STAFF REPORT

SUBJECT: Ringneck Place Subdivision AZ, PP
H-2023-0009

Annexation of 1.73 acres of land with an R-8 zoning district, Preliminary Plat consisting of 9 residential building lots and two (2) common lots on 1.539 acres for Ringneck Place Subdivision.

D. Conceptual Building Elevations

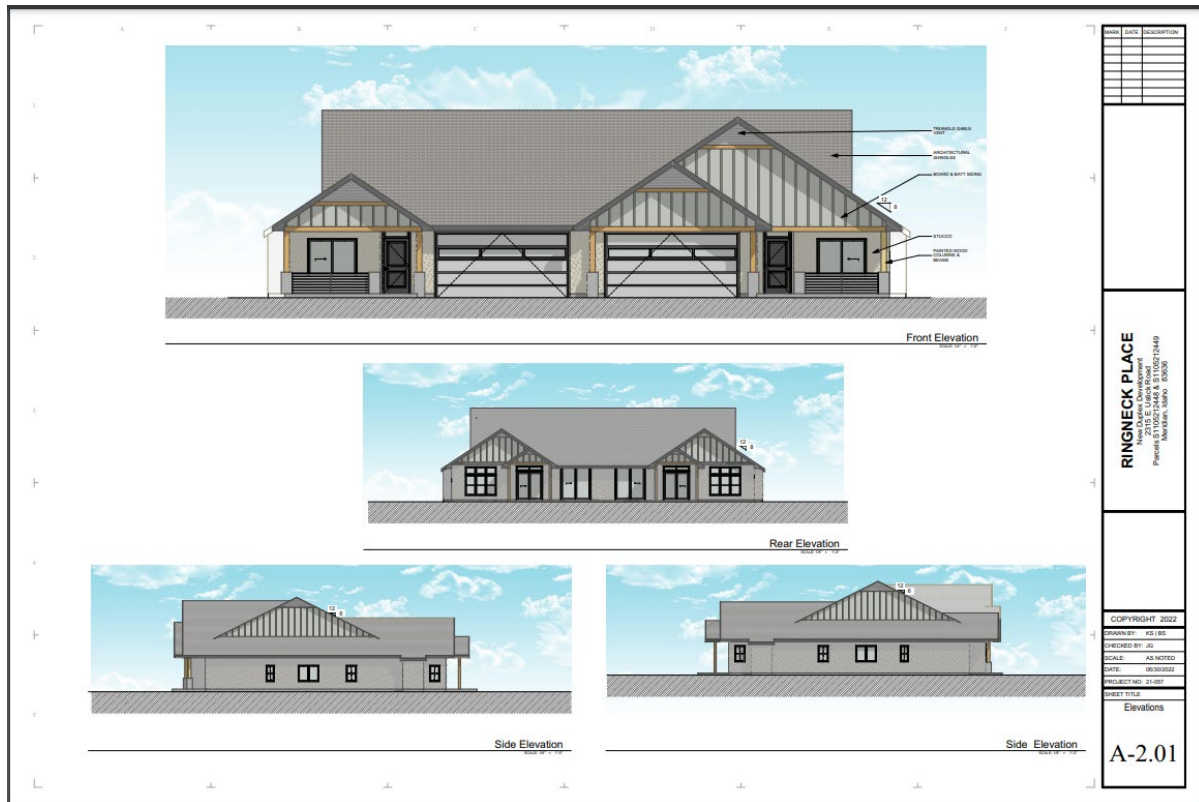
Building Elevations: Conceptual building elevations were submitted that demonstrate what future homes in this development will look like (see Section VIII.D). Variations of single-story homes with a two-car garage are proposed. *The submitted elevations depict a number of different architectural and design styles with field materials of lap siding, stucco, differing color accents, and roof profiles. Staff recommends that the Applicant add additional stone or brick accents to the front of the homes to provide more of a variation in materials and a combination of various colors for each unit. The Applicant shall submit elevations for the future single-family detached home with the Design Review*

11. A Design Review application shall be submitted and approved for the proposed single-family attached homes prior to submittal of a building permit application. The design standards listed in the [Architectural Standards Manual](#) and the Development Agreement. The Applicant shall submit revised elevations that include a mix of stone and/or brick as well as submit elevations for the future single-family detached home with the Design Review Application.
